Carlon[®]
LAMSON & SESSIONS

2005 National Electrical Code Changes Relevant to Carlon Products

Figure 210.52 Determination of Area Behind Sink or Range.

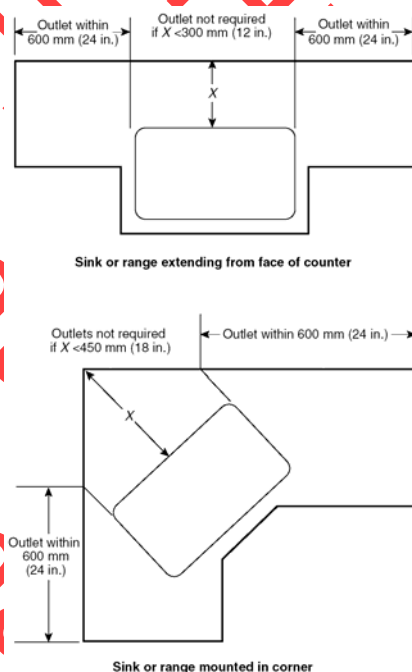
210.52(C)(1) Exception Wall Counter Spaces: (Outlet Boxes). Receptacle outlets shall not be required on a wall directly behind a range or sink in the installation described in Figure 210.52.

What does this mean?: Outlet boxes will not be required to be installed behind a sink or range to fulfill the requirement for an outlet box every 24 inches. The width of the sink or range is not to be included in the spacing of the outlet boxes unless the distance from the sink or range to the wall is greater than 12" for straight counter tops and 18" for sinks and ranges installed in corner counters.
